# Sound Transit III

## ***Guideway and Station Location***

*Preparing for Station Area and TOD planning*

# Prospect

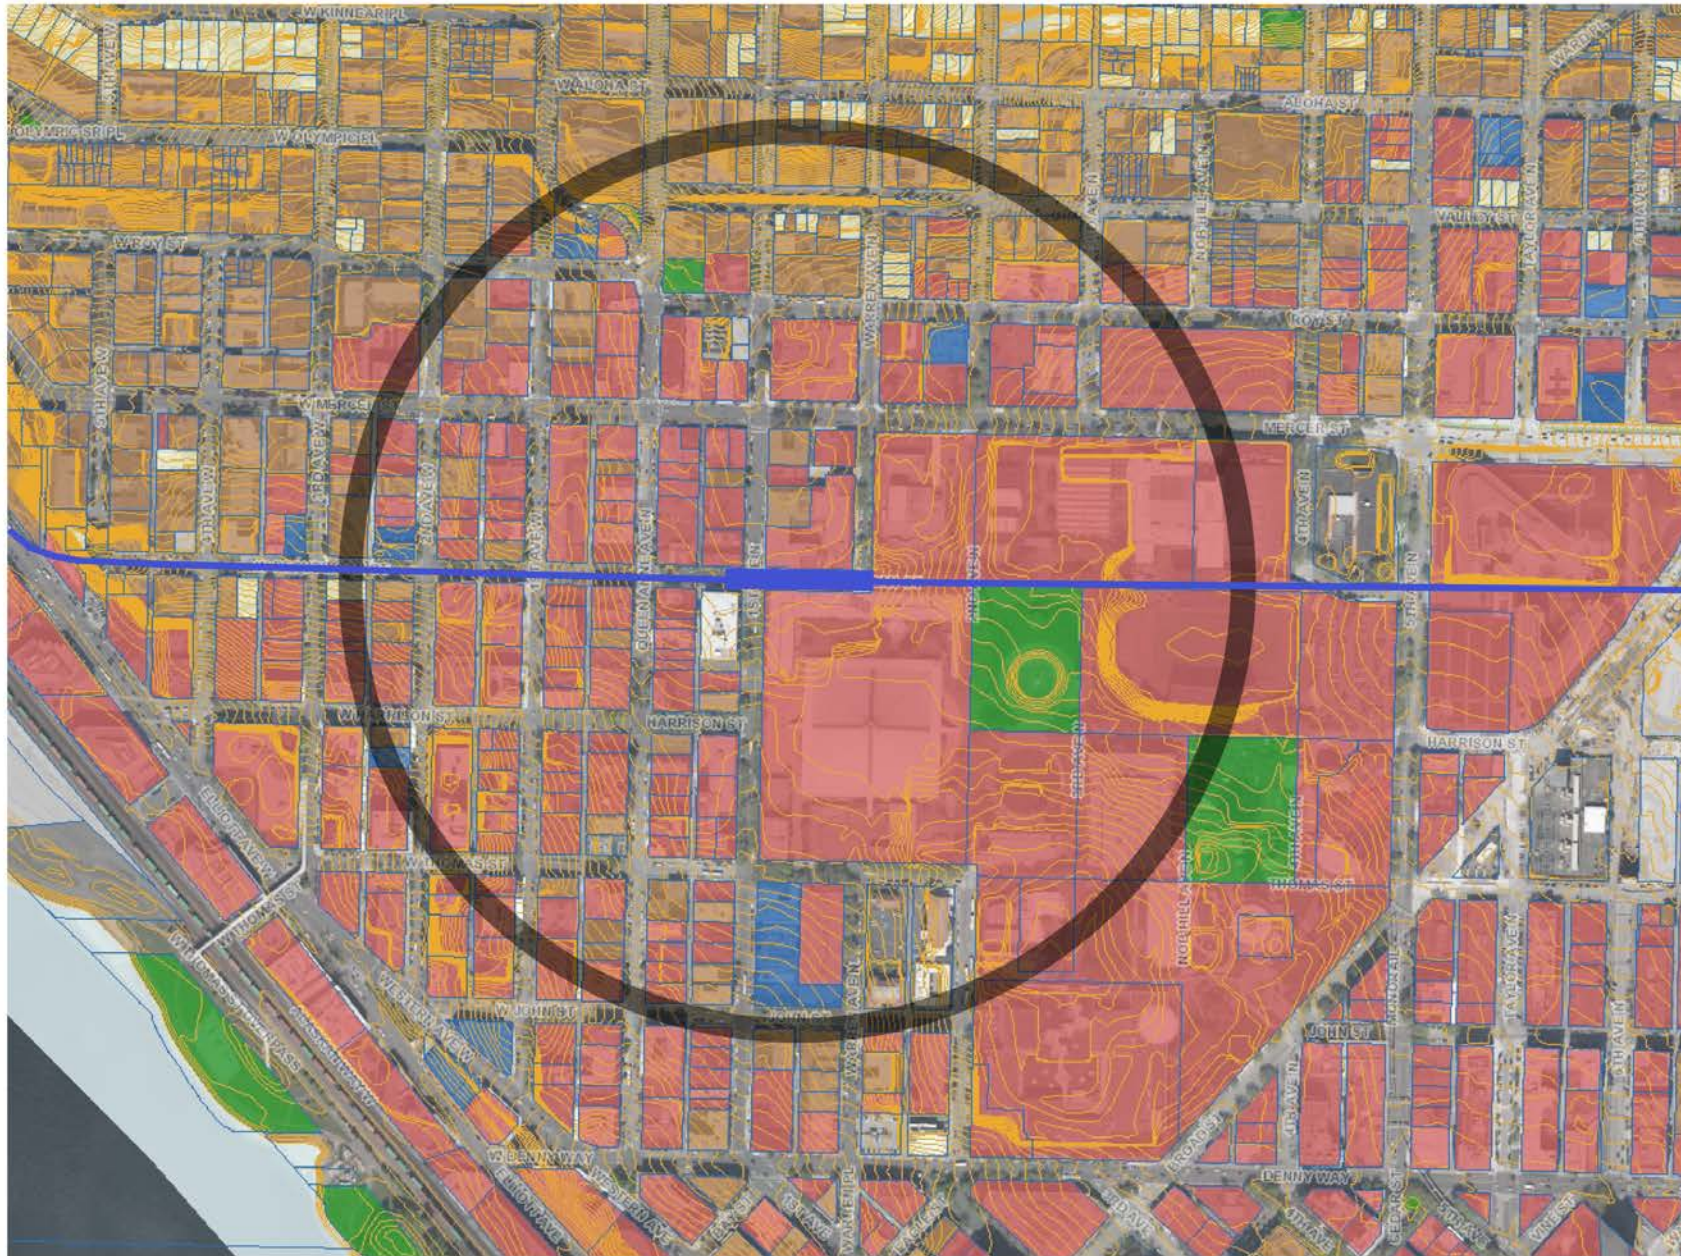
- Improve pedestrian connections to Queen Anne
- Stop is very reliant on Expedia - strong TMP needed
- Proximity to Galer flyover could enable connections to both T91 and Expedia

# Seventh (SR 99)

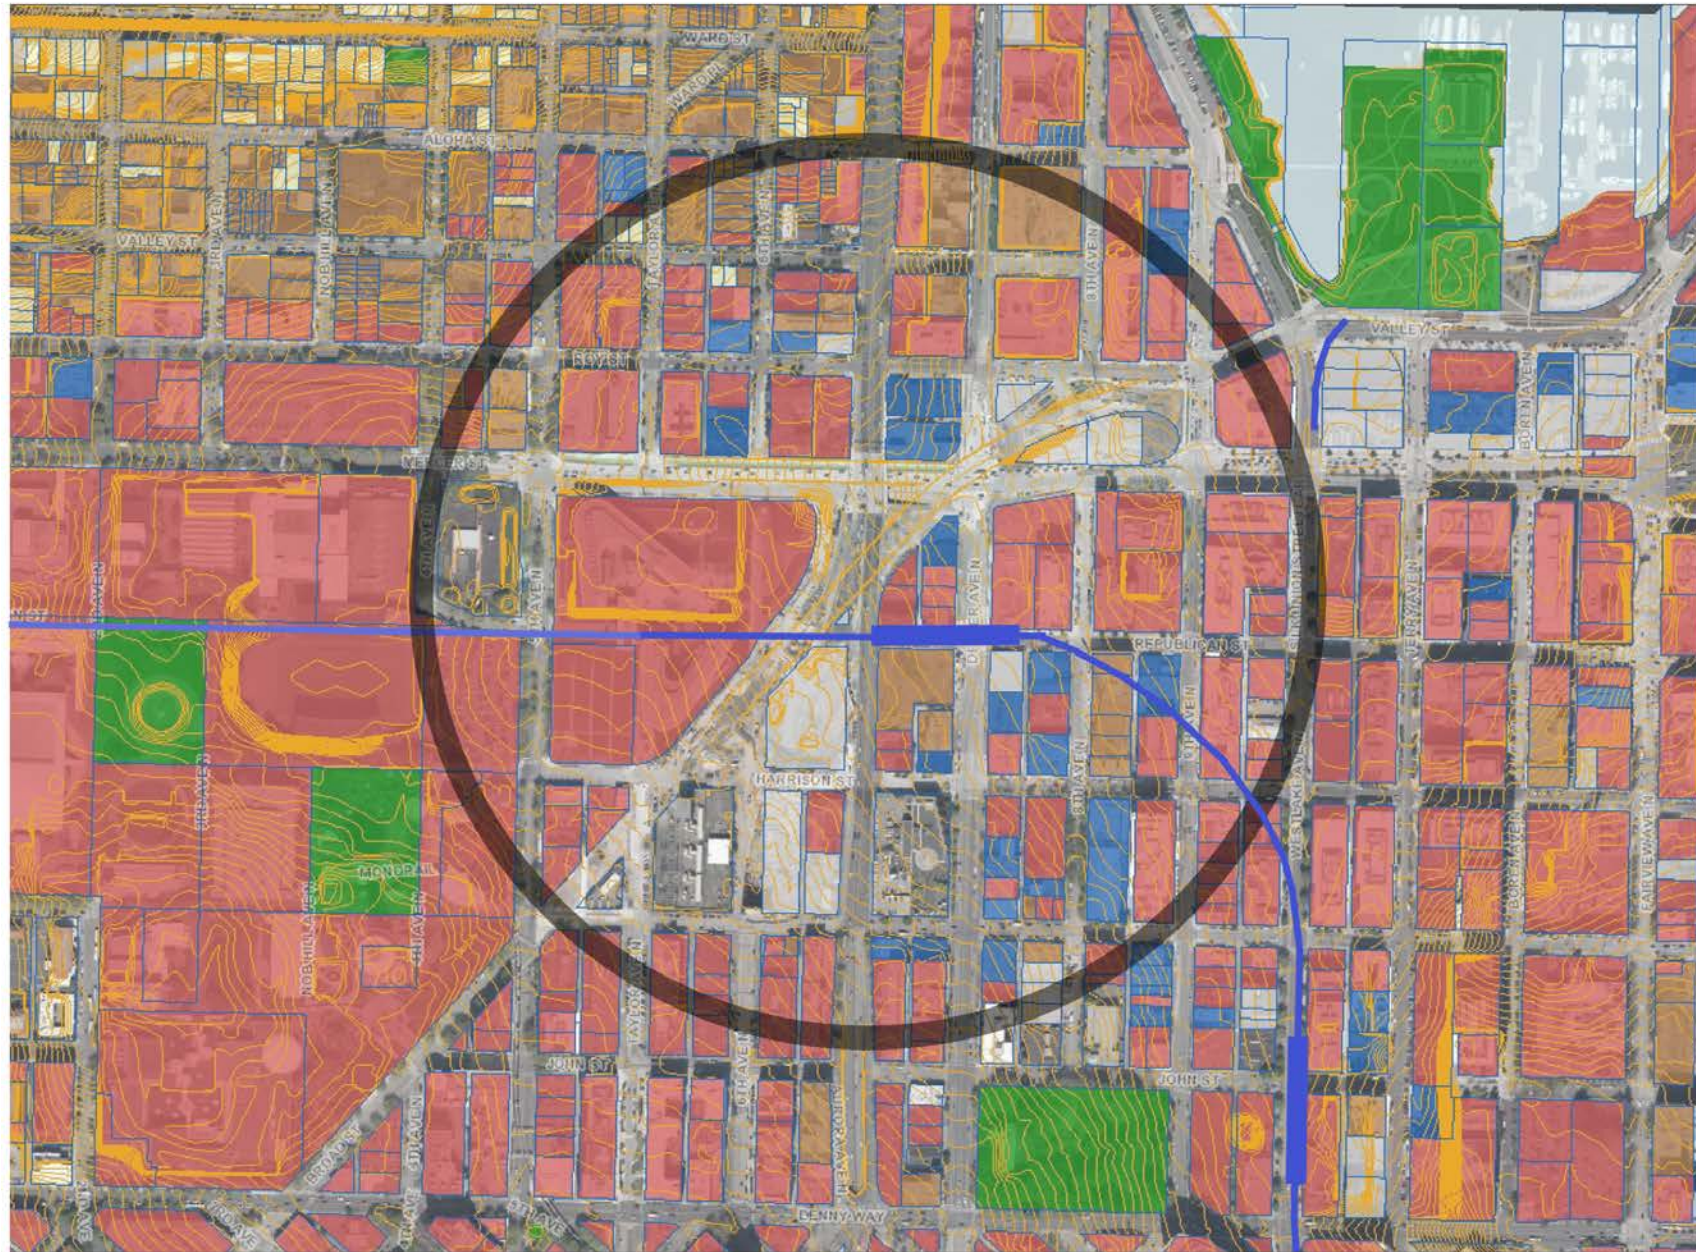
- Poor connections to Transit/Gates Foundation
- Consider connection across Mercer
- Station spacing

# Westlake

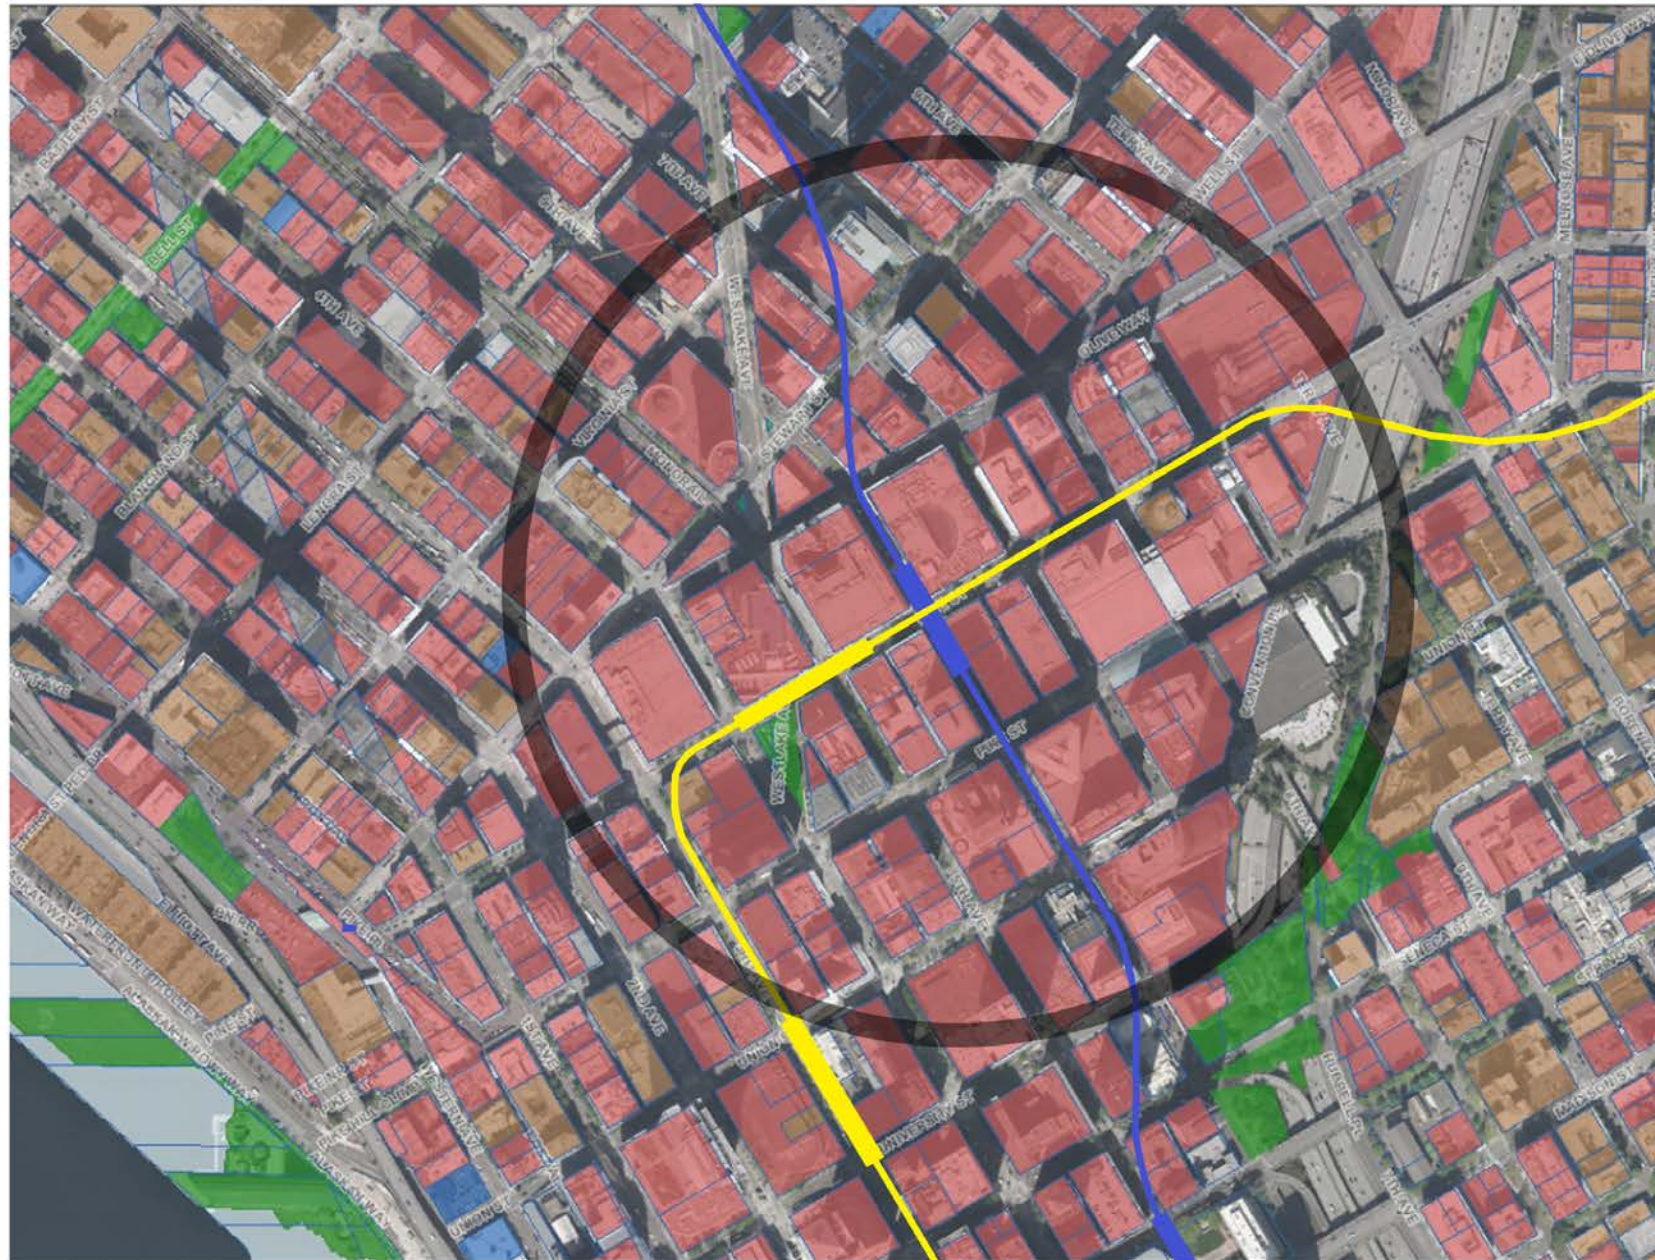
- Maximize number of station entrances including McGraw Square
- High speed elevator at this location (lots of tourists with baggage)
- Coordinate with Pike Pine Renaissance project

# Madison

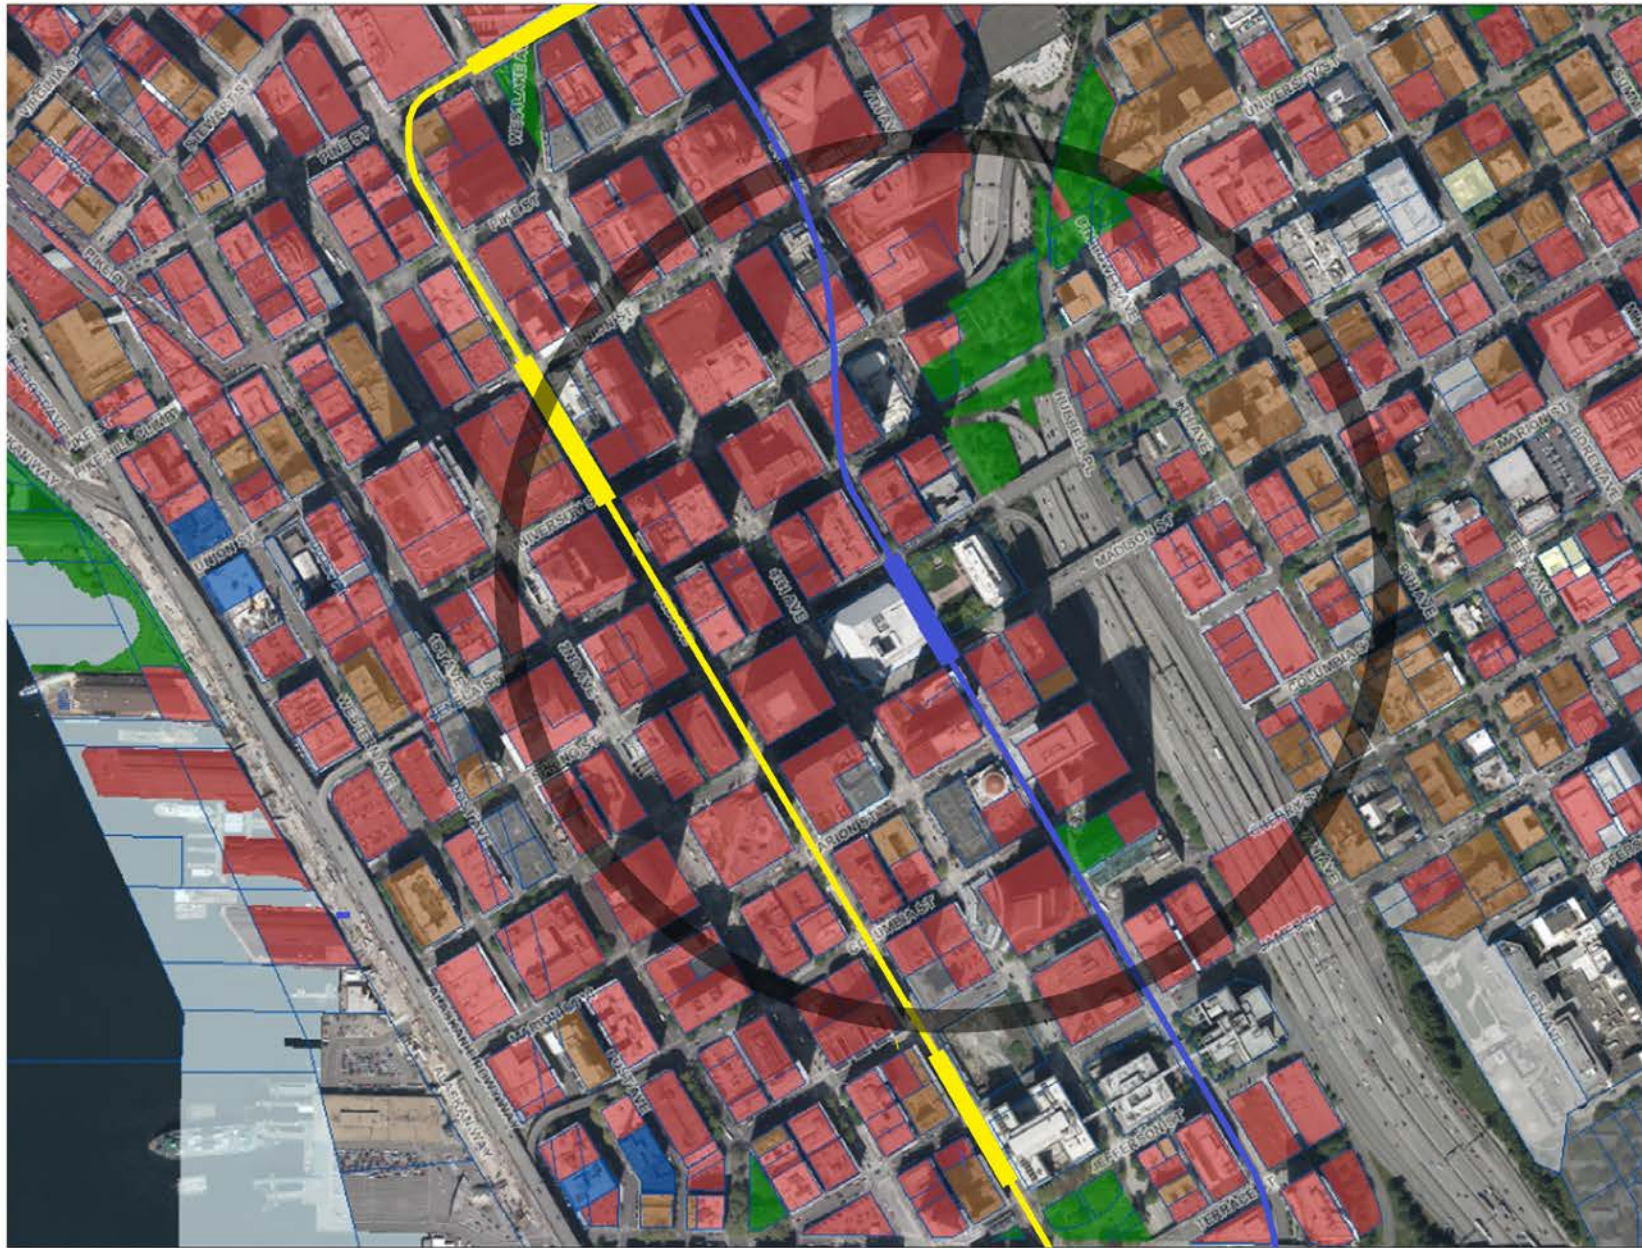
- Improve the I-5 overpass at Seneca
- Entrances could activate Freeway park

# Chinatown/ID

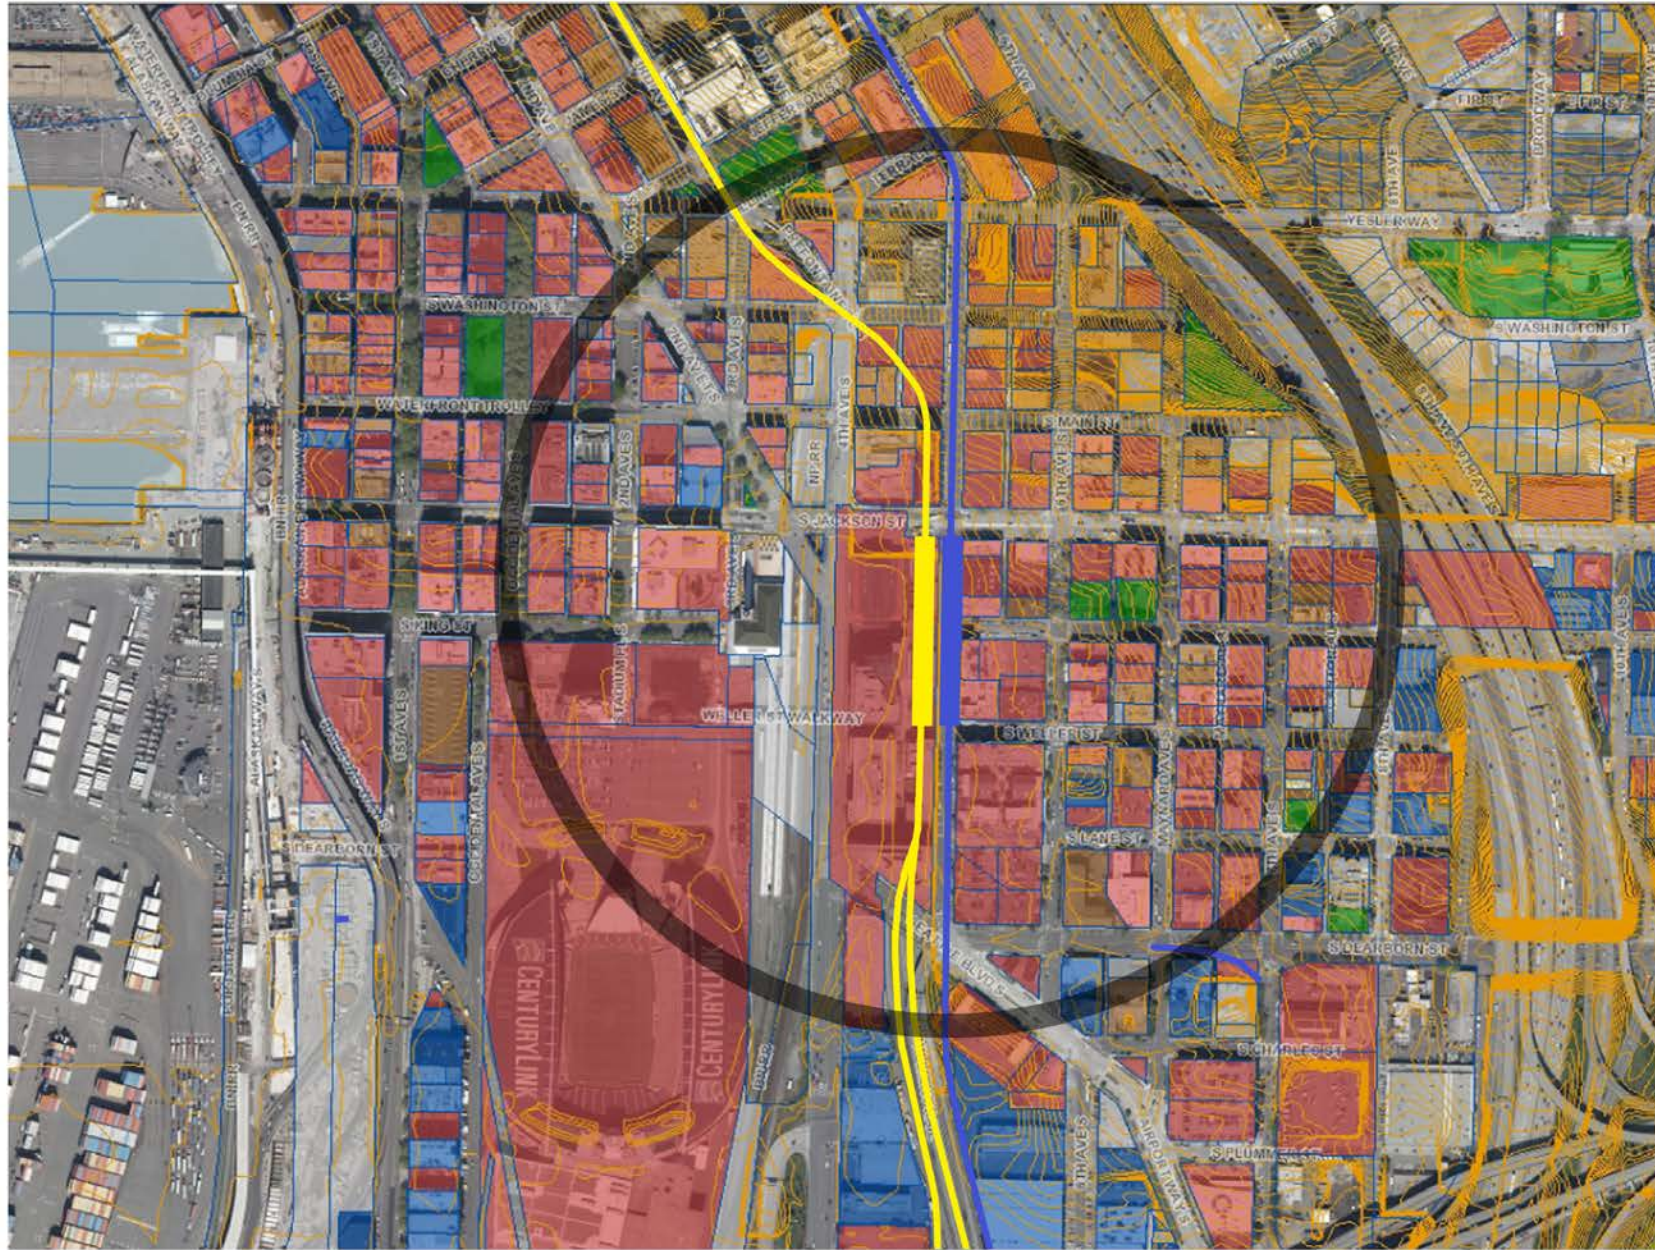
- Primary transit transfer point
- Inter-station connectivity important
- Impacts on community from proposed cut and cover on 5th
